ANN ARBOR HISTORIC DISTRICT COMMISSION

Staff Report

ADDRESS: 418 S First Street, Application Number HDC14-009

APPLICATION: This application seeks to modify the approved garage/studio design by removing the south-facing dormer and three small windows on the south elevation and installing 26 black-on-black solar panels that span the width of the roof.

SOUTH ELEVATION

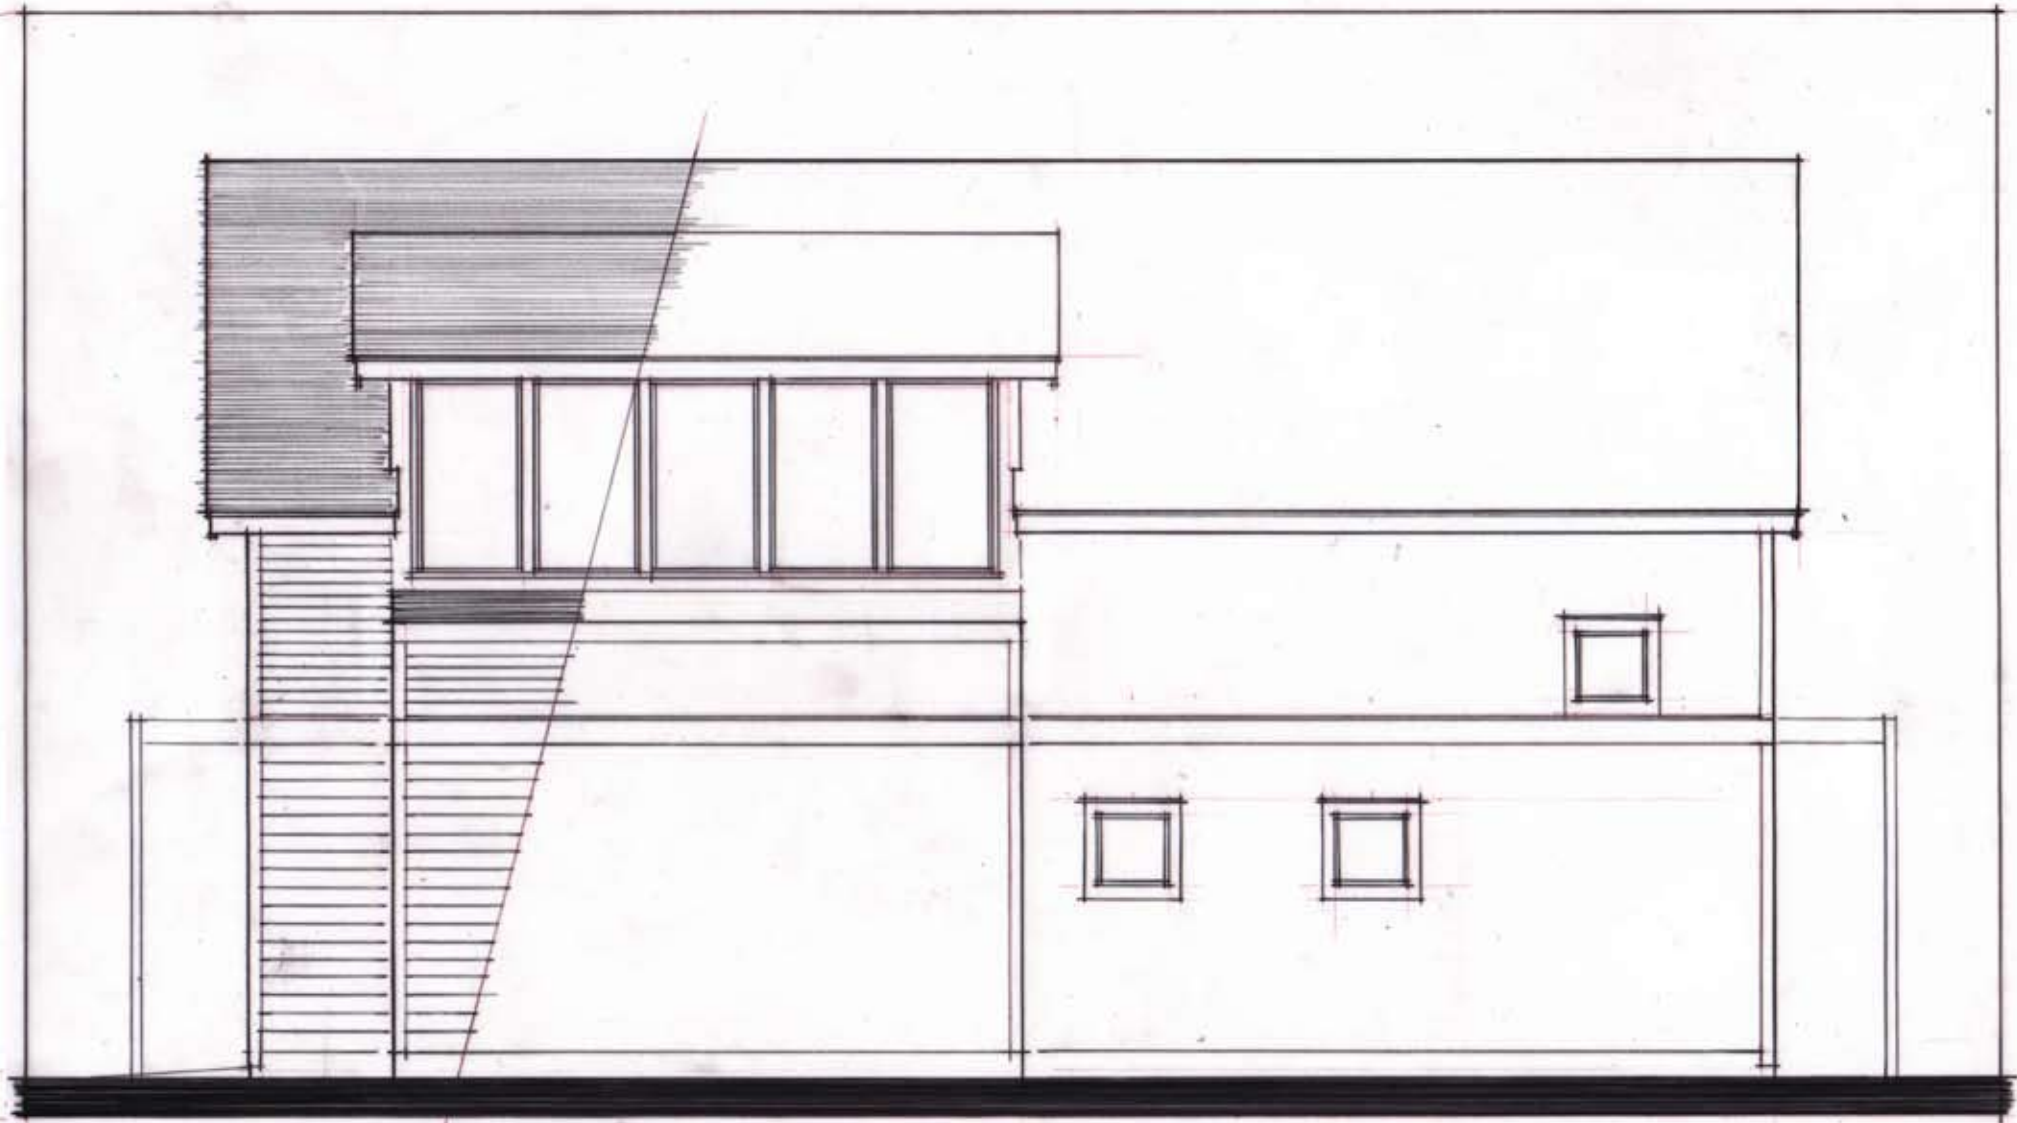
1. Each panel is 40" x 66", and just over an inch thick. The panels and their frames are black, and will cover the roof to within approximately a foot of the edges and ridge, per the supplied drawing. The applicant emailed that they haven't picked a roof color yet, but that it would be a medium to dark color. Since the panels are being installed on a new accessory structure, staff feels this is acceptable.
2. Removal of the south dormer and windows has no negative effect on the compatibility of the new garage/studio with surrounding resources.
3. Staff believes that the materials and design of the panels are compatible with the design of the new structure, neighboring contributing and non-contributing buildings, and the surrounding historic district, and meet both the Secretary of the Interior's Standards and the *Ann Arbor Historic District Design Guidelines*.
